ALNRC 00025
May 15, 2009

Enclosure A

Red-line strikeout changes to Section 9.3 of the ER

9.3 ALTERNATIVE SITES

Figure 9.3-17—Chamois Candidate Site Transmission Plan

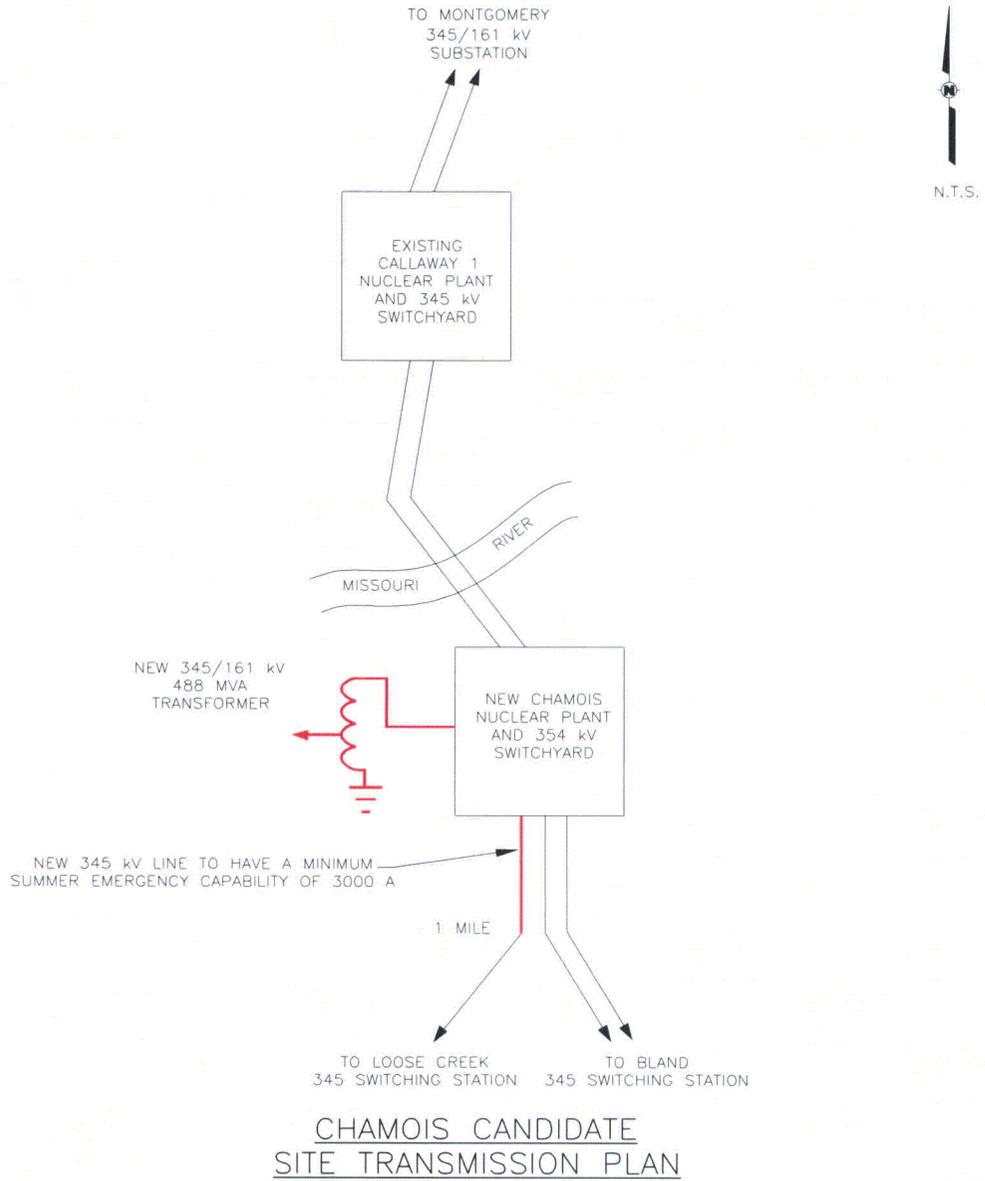
The site has been in use for electrical generation for many years. Figure 9.3-17 depicts the transmission plan for the Chamois candidate site. This site is adjacent to the existing Callaway-Bland transmission right-of-way. It is assumed that the existing Callaway-Bland 345 kV lines would be split at the new 345 kV switchyard to provide two outlet circuits to the north and two outlet circuits to the south. Although it will be necessary to build new infrastructure to accommodate the new output for the plant, it is anticipated that existing corridors would be sufficient to accommodate construction. A new 1-mile (1.6 km) line extension would be required from the new switchyard to the existing Callaway-Loose Creek 345 kV line. A rough cost of \$800,000 is assumed for the new line extension. The plant site is developed and the surrounding corridors are traversing predominantly agricultural land. In addition, the current transmission system could be used with limited or no modifications. It is anticipated that the impacts due to transmission corridors would be SMALL.

Figure 9.3-18—Fred Weber Quarry Candidate Site Transmission Plan

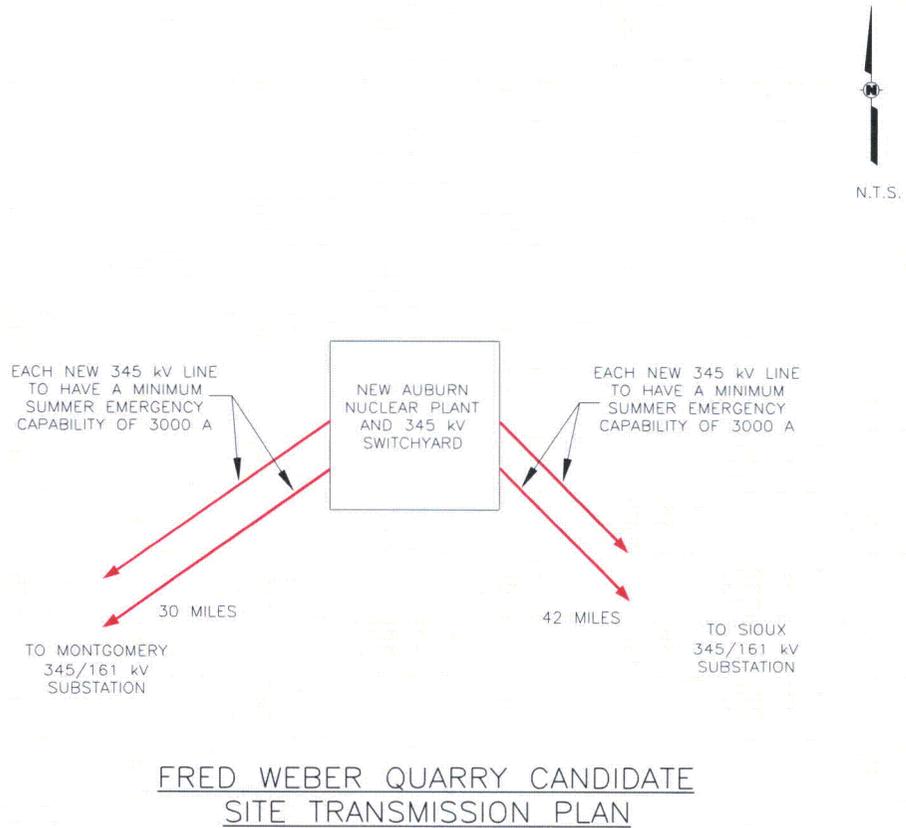
Figure 9.3-18 depicts the preliminary transmission plan for the Fred Weber Quarry candidate site. This site in northern Lincoln County, Missouri, is not close to any existing 345 kV lines. It is assumed that two 42-mile 345 kV lines would be required to connect the new switchyard to the Sioux 345/138 kV Substation and two 30-mile 345 kV lines would be required to connect to the Montgomery 345/161 kV Substation. The new lines to the Sioux substation could follow a portion of the AmerenUE-owned Troy-Cyrene section of the Troy-Pike 161 kV line or the

Sioux-Belleau section of the Sioux-Montgomery 345 kV right-of-way. New 345 kV line extensions would total 144 miles (232 km) at an estimated cost of \$115.2 million. The site has been in use as a stone quarry for many years. It will be necessary to build new infrastructure to accommodate the new output for the plant. The plant site is developed and the surrounding corridors are predominantly agricultural land. In addition, the current transmission system could be used with few or no modifications. It is anticipated that the impacts due to transmission corridors would be LARGE.

Figure 9.3-21—Farmland on the Chamois Site

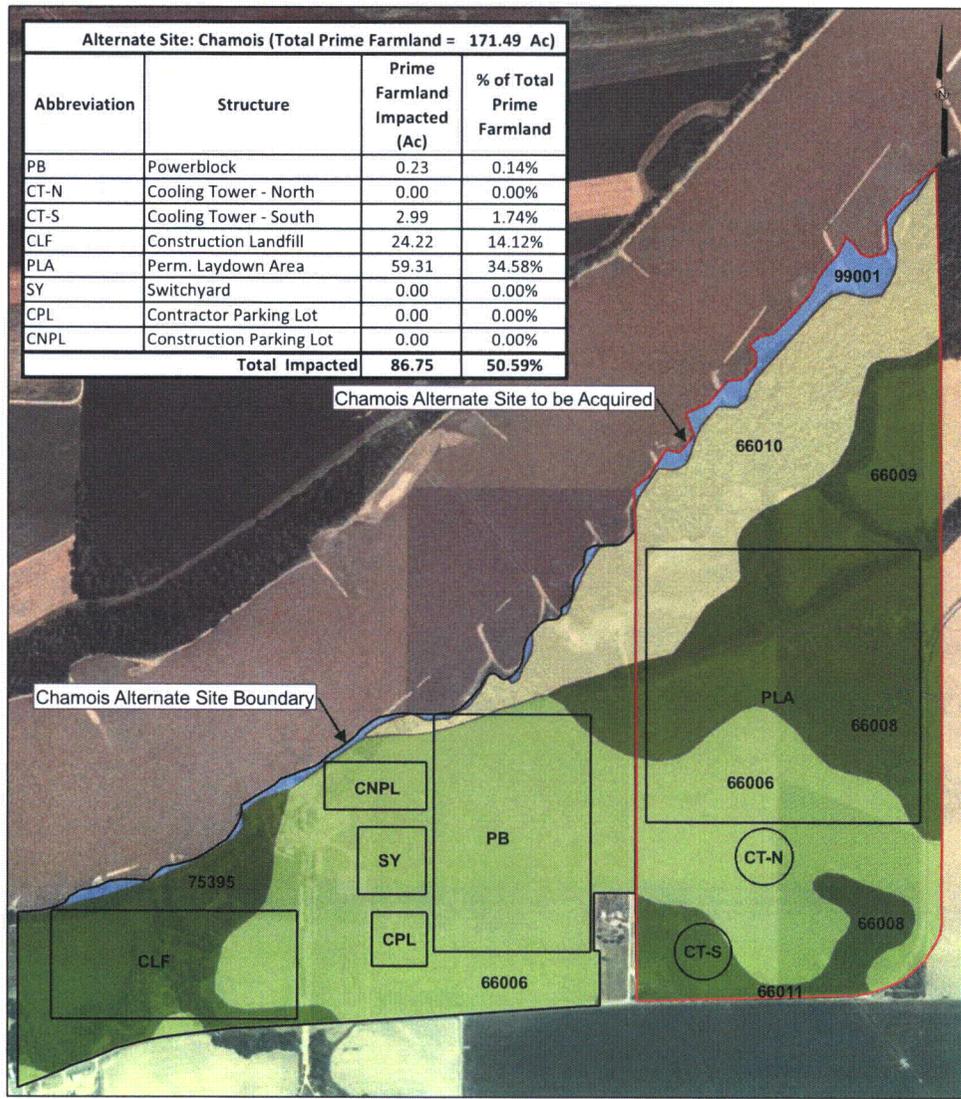
The U. S. Department of Agriculture - Natural Resource Conservation Service (NRCS) has mapped the soil in Osage County and has classified the soil at the site in two categories, as "Prime farmland if drained" and as "All areas are prime farmland" (NRCS, 2006a). Approximately 171 acres (69 hectares) of the Chamois site, including the land to be acquired, have been classified as prime farmland. Of this, approximately 50 percent (87 acres (35 hectares)) will be impacted by the proposed plant. Approximately 17 percent of the land within a 5 mile (8 km) radius surrounding the Chamois site has been classified as prime farmland, with approximately 0.17 percent of this to be disturbed with the proposed plant. Figure 9.3-21 shows farmland on the Chamois site, including the land to be acquired.

Figure 9.3-25—Farmland on the Callaway Site

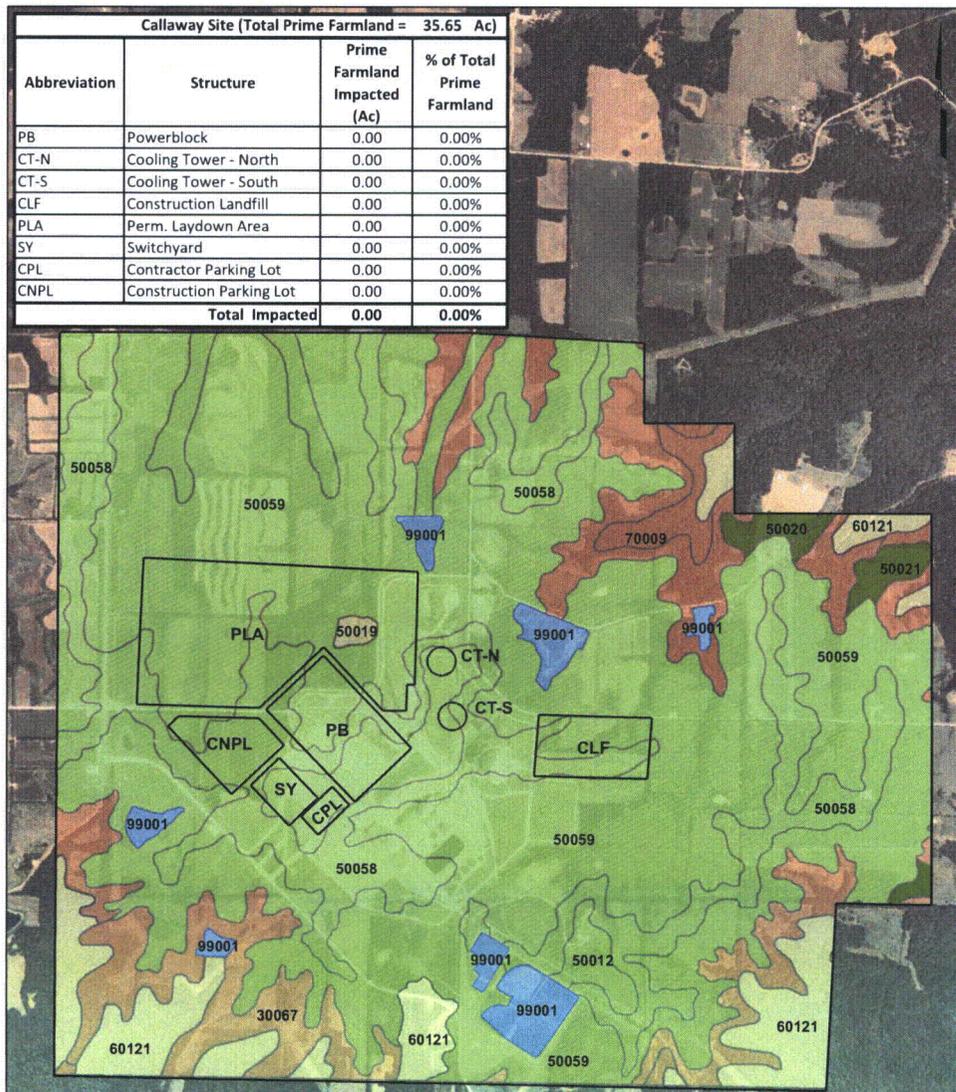
Approximately 36 acres (15 hectares) of the Callaway site has been classified as prime farmland. Of this, 0 percent (0 acres (0 hectares)) will be impacted by the proposed plant. This does not include the collector wells or intake pipes. Approximately 9 percent of the land within a 5 mile (8 km) radius surrounding the Callaway site has been classified as prime farmland, with 0 percent of this to be disturbed with the proposed plant. Figure 9.3-25 shows farmland on the Callaway site. Approximately 69 acres (28 hectares) of the Callaway site is National Wetlands Inventory (NWI) wetland. Of this, approximately 6 percent (4 acres (1.6 hectares)) will be impacted by the proposed plant. Figure 9.3-30 shows NWI wetlands on the Callaway site.
